Service Info

Over-running alternator pulley 535 0267 10

Visual differences

Part no.: 535 0267 10

Figure 1: Previous design

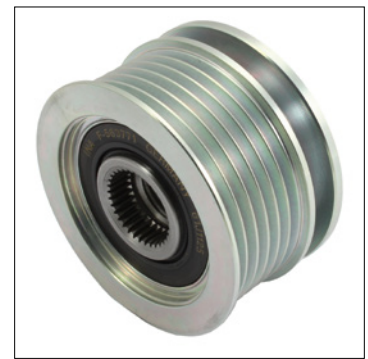
As part of our continuous efforts to improve our products, modifications have been made to the over-running alternator pulley with part number 535 0267 10.

This Service Information sheet shows the visual features of the previous version (Figure 1) and the new version (Figure 2).

The two versions differ only in their appearance. Both comply with the technical specifications and can be used without restrictions.
